TO: WARD PONTICELLI
FROM: JACKIE BROWN *JB*
SUBJECT: CORRECTION OF THE "STACK EFFECT" AND IMPROVEMENTS TO BUILDING PRESSURE CONTROLS AT 25 SIGOURNEY
DATE: 08/06/01
CC: MANUEL BECERRA, DONNA BAISLEY

**AIR FLOW STUDY
FOR
25 SIGOURNEY STREET
HARTFORD, CT.**

Re: 25 Sigourney Street
6th Floor HVAC Testing

RE: 25 SIGOURNEY ST. - VENTILATION TESTING

SK-1

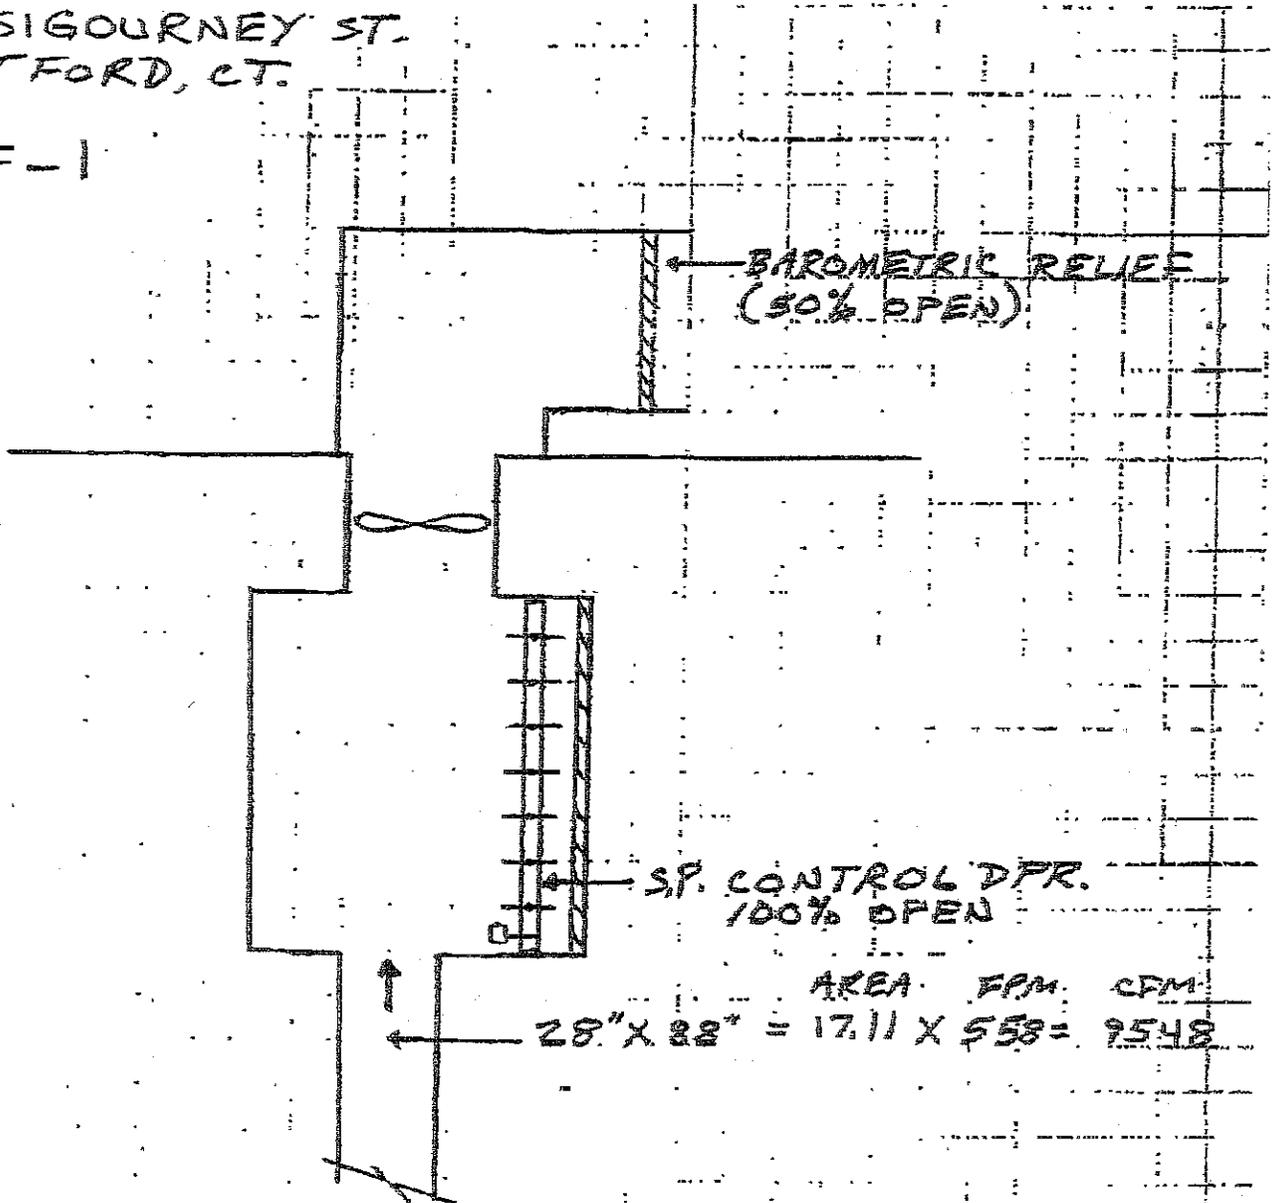
Description	Exiting CFM
* SEF-1 (Smoke Exhaust Fan) has a barometric relief back draft damper which is spilling air and the automatic damper is wide open (see sk-1)	9,548
* Elevator machine room roof has a 5'x5' opening to a louvered relief vent	14,675
* Kitchen exhaust fans that are not running, have fan discharge wire mesh screens that are relieving 350 FPM: 44" dia = $138" \times 10" = 9.59 \times 350 = 3358$ 35" dia = $110" \times 9" = 6.87 \times 350 = 2404$	5,762

- * Contract a HVAC engineering firm to review our report and findings, in addition to addressing code issues, etc. (Note: BVH Engineers, Inc. has first hand information on the base building design.)
- * Eliminate air leakage
 - isolate the SEF-1 relief damper (sk-1)
 - close the static pressure control damper (sk-1)
 - close the elevator shaft ventilation relief
 - tighten the sliding door tracks
 - seal the mullions at the fixed pane windows
- * Adjust the make up air fan systems to provide adequate ventilation for occupants and building pressurization

SK-1

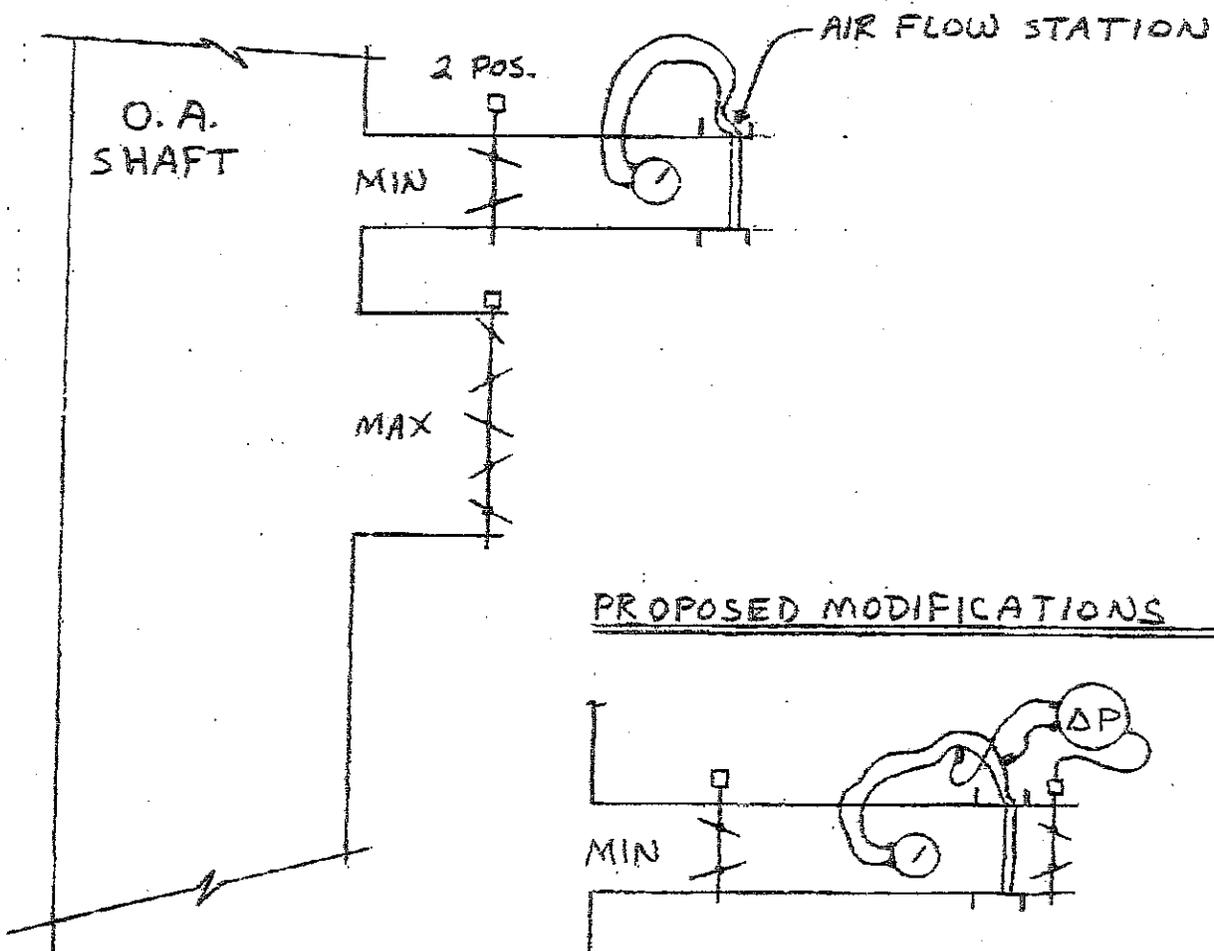
- * UPGRADE THE CONTROLS TO PROVIDE AUTOMATIC RELIABLE CONDITIONS. (WHEN THE ΔP SENSOR LO SIDE WAS CONNECTED TO ATMOSPHERE, NO CHANGE TO SYSTEM SPEED OCCURRED.)
- * ADD A DUCT EXTENSION TO THE MIN. SECTION WITH A VOLUME DAMPER TO CONTROL FROM THE EXISTING AIR FLOW STATIONS. (SEE SK-1)

THE NEW DAMPER TO BE CONTROLLED BY A ΔP SENSOR TIED INTO THE AFS.
